CITY OF ALBUQUERQUE

RE: **4517 Las Hermanas NW**
Grading and Drainage Plan
Engineer's Stamp Date: 12/4/19
Hydrology File: G15D066

Based on the submittal received on 1/6/20, the above-referenced Grading and Drainage Plan cannot be approved until the following are corrected:

A4 SIDEWALK CULVERT DETAIL
SCALE: NOT TO SCALE

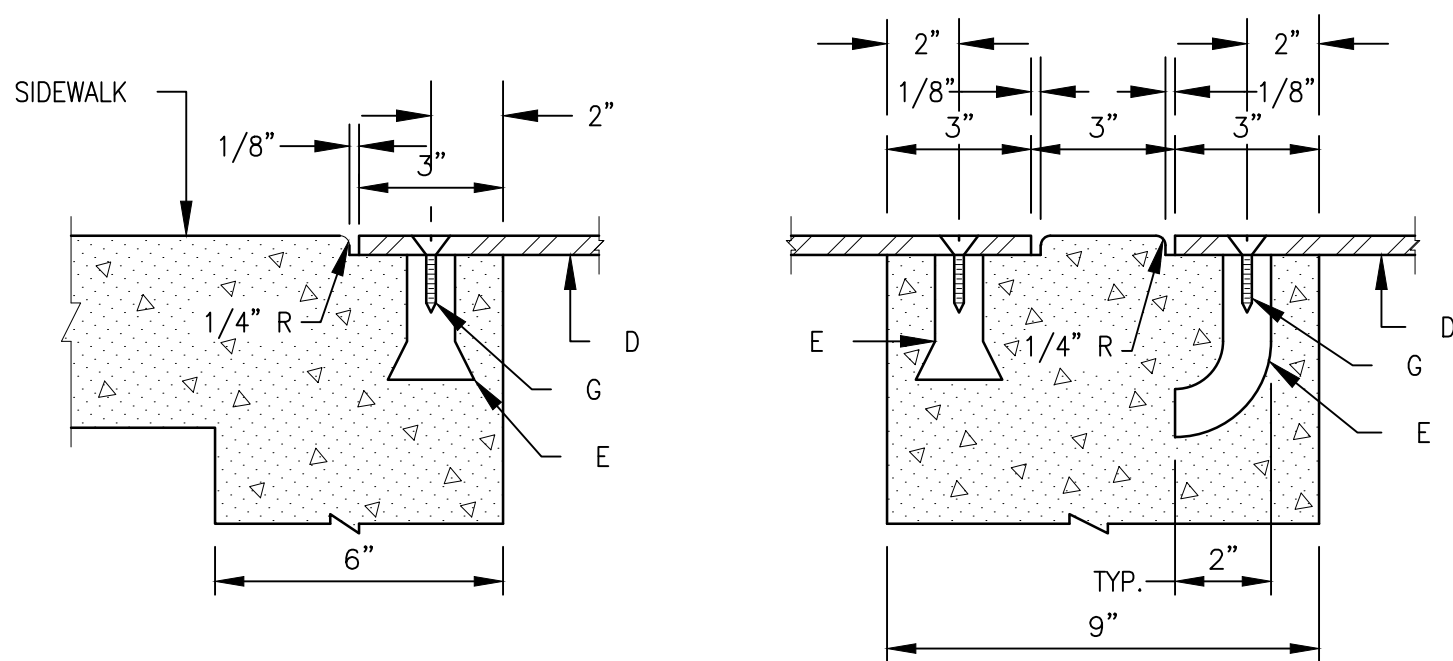
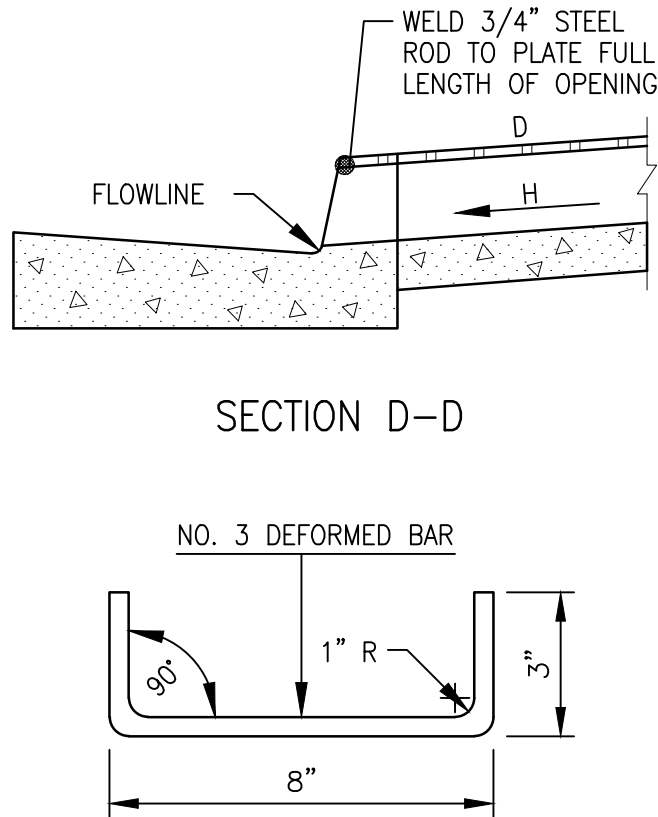
4. Stormwater Quality requirements do not need to be met for individual residences, so this narrative can be removed. Also, sidewalk culverts are not required for less than collector streets, so this work (and the SO-19 permit requirement) can be removed if desired.
